LARAMIE COUNTY PLANNING & DEVELOPMENT DEPARTMENT

MEMORANDUM

TITLE: PUBLIC HEARING regarding a Zone Change from A-1 to AR for a portion of the W1/2, NE1/4, NW1/4 of Section 5, T14N., R66W., 6th P.M., Laramie County, WY and a Subdivision Permit and Plat for Beer Gardens Subdivision, Laramie County, WY.

**Beer Gardens Subdivision
PZ-23-00120
PZ-23-00161**

BEER GARDENS

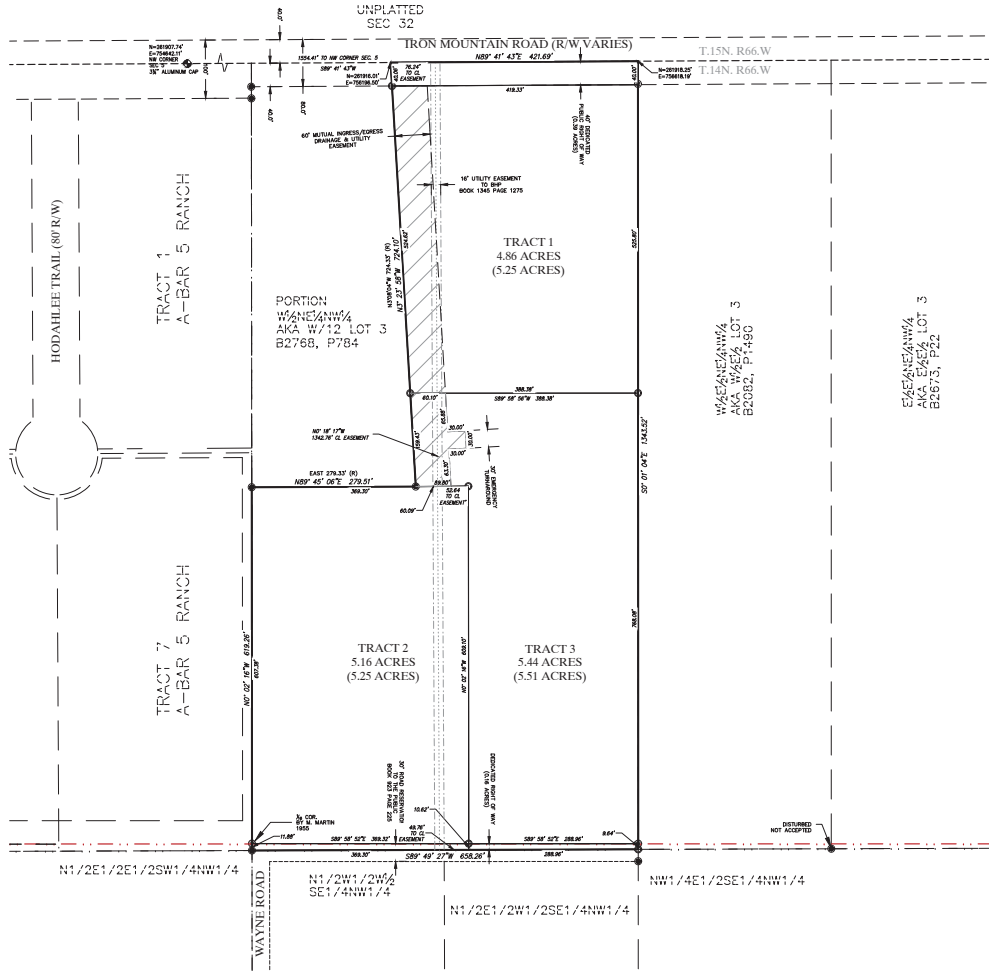
10/04/2023		Workflow	PUBLIC WORKS REVIEW	GENERAL	<p>1. The line work shown on this plat is confusing to a non-surveyor. Please update the legend on the plat to include the line types.</p> <p>1a. Is it the intent of this plat to dedicate the 40 foot Iron Mountain right-of-way (ROW) and the 30 foot public road dedication on the South boundary (AKA Wayne Road)?</p> <p>1a. Based on our interpretation of the Commissioner's minutes from November 16, 1976 and the deed (Book 923 page 225) (both are attached in other comments), these Rights-of-way have been previously dedicated.</p> <p>2. Is it the intent of this plat to dedicate the 85 foot utility and access easement? There is no book and page referenced.</p> <p>3. Access for these lots will be shared from one access off of Iron Mountain. The access at 1733 IRON MOUNTAIN RD shall be expanded and utilized for these lots.</p> <p>3a. An access permit application through Public Works will be required. Call (307-633-4302) or email (permits@laramiecountywy.gov) Public Works for more information.</p> <p>3b. Laramie County Land Use Regulations access paving requirements shall be followed.</p> <p>4. A note shall be added to the plat indicating "there will be no public maintenance of internal roadways/access easements."</p> <p>5. All comments from the review engineer and surveyor shall be addressed.</p>	MOLLY.BENNETT@LARAMIECOUNTY.WY.GOV

10/04/2023	10/04/2023	Application	PZ-23-00120	GENERAL	<p>Engineer Review</p> <p>1.I concur with the request for a waiver of a detailed Drainage Study and Traffic Study since this development will have negligible impact on both.</p> <p>2.The existing driveway and approach need to be upgraded to a standard County roadway that will remain within the 85 Access & Utility Easement and will serve all three Tracts and the property immediately to the west that the current existing access/driveway serves. No additional access will be allowed off Iron Mountain Road. A note should be added to the plat to indicate this (it is mainly for Tract 1). Roadway design plans meeting County requirements will need to be submitted to the County with a ROW permit to be reviewed and approved.</p> <p>3.The 85 Access & Utility Easement should include an easement for a hammerhead, cul-de-sac or some other approved dead-end fire apparatus access road turnaround per LCLUR.</p> <p>4.The new roadway will need to be paved from Iron Mountain to a minimum of the right-of-way for Iron Mountain.</p> <p>5.This does not appear to be an Administrative Plat. Therefore, additional approvals/signatures are needed on the plat for the Commissioners and Clerk.</p> <p>Surveyor Review</p> <p>1.There are boundary ties for the 85 ACCESS & UTILITY EASEMENT at three different locations on the plat. After</p>	SCOTT.LARSON@LARAMIECOUNTY.WY.GOV

checking by scaling the dimensions to determine the end point locations of the ties, it appears that the dimensions of the ties shown are to the center line of the easement. It would be helpful to the lay user of the plat if those dimension ties would somehow be shown or labeled to indicate they are ties to the center line of the easement.

10/11/2023		Application	PZ-23-00120	GENERAL	LCPC Hearing 12/14/2023 BOCC Hearing 1/2/2024	CATHERINE.CUNDALL@LARAMIECOUNTY.WY.GOV
10/12/2023		Workflow	PUBLIC WORKS REVIEW	GENERAL	PW review 2: 1. A note shall be added to the plat indicating "there will be no public maintenance of internal roadways/access easements." 2. With the submittal of the application online, applicants have access to the reviews and information (i.e. the attachments referenced). Feel free to reach out to the Planning office for assistance. 3. In reference to the 85 foot easement intended to be "dedicated" on this plat, please update the dimension callout/tag indicate "this plat". 4. Update the legend to show all line types on the plat. 5. Comments are forthcoming from the review engineer and County Attorney regarding access along the southern boundary.	MOLLY.BENNETT@LARAMIECOUNTY.WY.GOV
10/16/2023		Workflow	ENVIRONMENTAL HEALTH REVIEW	GENERAL	Small wastewater permits are required for each lot. Small wastewater systems cannot be installed in easements. Property line setbacks are fifty feet for small wastewater systems. Signed final plat is required to be submitted to Environmental Health before permits can be issued	TIFFANY.GAERTNER@LARAMIECOUNTY.WY.GOV

though the deed indicates the 30 is for the use of the Public as a Public Road, a deed cannot establish a public road unless the County accepts it onto their system. In this case, it does not appear the County has accepted it, established it, and designated it as a public road or ROW. Therefore, there may not be legal access for use of this 30 to access the proposed Tracts. As a result, there needs to either be a newly established ROW or access easement for the proposed Tracts and the 10 that this plat is dedicating is not adequate. I personally see 3 potential options; If the plat included the full 30 of the road that was established via the deed and dedicated that full 30 and 50 additional, that would be one option. This would require additional property owners signing off on the plat. The second option would be to establish an 80 ROW or easement that is entirely located on platted property which would avoid the potential access issues to the 30 road. The third option would be to not allow any access along the south property line and utilize the 85 access easement off Iron Mountain shown on the plat for the only access to these Tracts.

2.The decision on where the Tracts will access also needs to be determined at this time to establish the appropriate address for the Tracts; whether they will be address off Iron Mountain or the newly established roadway on the south side of the platted area.

3.Regardless of which access is used to access Tracts 2 and 3, (i.e., the 85 easement or an 80 ROW needed for the southern roadway) an emergency an emergency turnaround meeting the LCLUR is needed for the roadway that is chosen. This needs to be in the form of an easement or ROW. This is another reason why it is important to know where Tracts 2 and 3 will be accessing.

4.I would suggest that the label on the plat of the existing 30 road be changed to reflect the exact wording of Book 923, Page 225 and it should read 30 for the use of the Public as a Public Road. However, given its potential legal issues with the wording, I would also suggest that there be a note or a label indicating something along the lines that this wording is from the deed of the property and this 30 area has not been established by the County as a Public Road or to be used by the Public unless documents can be found to indicate the County did establish this as a public road or ROW.

1. With the decision to utilize the 85 access easement to access all Tracts, no access shall be allowed for Tract 2 or 3 from the south.

2. Roadway construction plans/designs shall be submitted to the County for review and approval of the roadway to be constructed within the 85 easement. The designs for the roadway shall meet all the requirements of the LCLUR. The roadway will need to be constructed and inspected by the County prior to building permits being issued.

1. All comments from the review engineer shall be addressed.
2. With this development action, the 85 foot access easement shall be built and/or brought up to current County Standards. A right-of-way/grading permit will be required. Call (307-633-4302) or email (permits@laramiecountywyo.gov) Public Works for more information.

1. A note shall be added to the plat indicating "there will be no public maintenance of internal roadways/access easements." **Added.**
2. With the submittal of the application online, applicants have access to the reviews and information (i.e. the attachments referenced). Feel free to reach out to the Planning office for assistance. **The road right of way was declared not dedicated. There is a difference. The County can't dedicate a road they don't own. We have now dedicated the 40 feet to Iron Mountain.**

3. In reference to the 85 foot easement intended to be "dedicated" on this plat, please update the dimension callout/tag indicate "this plat". **Not dedicated, easement.**

4. Update the legend to show all line types on the plat. **This is a Steil Surveying product, not a Laramie County product. Everything is labeled and all line types are different.**

5. Comments are forthcoming from the review engineer and County Attorney regarding access along the southern boundary. **The 30' access on the south is an easement granted to the public. Not a dedicated road. We dedicated the errant acreage from the erroneous survey to the public easement.**

establish an 80 ROW or easement that is entirely located on platted property which would avoid the potential access issues to the 30 road. The third option would be to not allow any access along the south property line and utilize the 85 access easement off Iron Mountain shown on the plat for the only access to these Tracts. We will utilize the easement on the plat created by the plat for access. Please see updated easement on plat.

2. The decision on where the Tracts will access also needs to be determined at this time to establish the appropriate address for the Tracts; whether they will be address off Iron Mountain or the newly established roadway on the south side of the platted area. Acknowledged

Acknowledged. Please see adjusted access easement.

4. I would suggest that the label on the plat of the existing 30 road be changed to reflect the exact wording of Book 923, Page 225 and it should read 30 for the use of the Public as a Public Road. However, given its potential legal issues with the wording, I would also suggest that there be a note or a label indicating something along the lines that this wording is from the deed of the property and this 30 area has not been established by the County as a Public Road or to be used by the Public unless documents can be found to indicate the County did establish this as a public road or ROW. Acknowledged.
